UNITED STATES PATENT AND TRADEMARK OFFICE

APPLICATION NO.	FILING DATE	FIRST NAMED INVENTOR	ATTORNEY DOCKET NO.	CONFIRMATION NO.
10/086,862	03/04/2002	Xuesong Chen	9351-97	9938

Office Action Summary

DETAILED ACTION

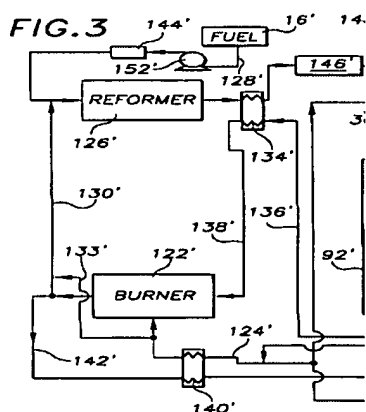
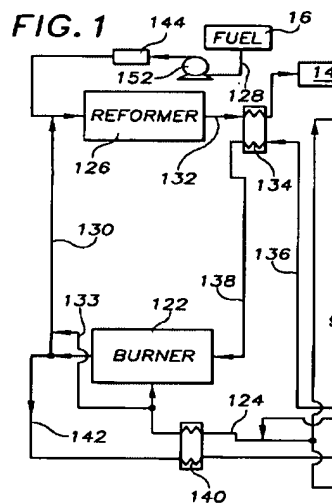
Figures 1 and 3 below shows that the burner 122 per se supplies an exhaust stream 130 to the reformer 132 which further process the fuel to be fed into the fuel cell.
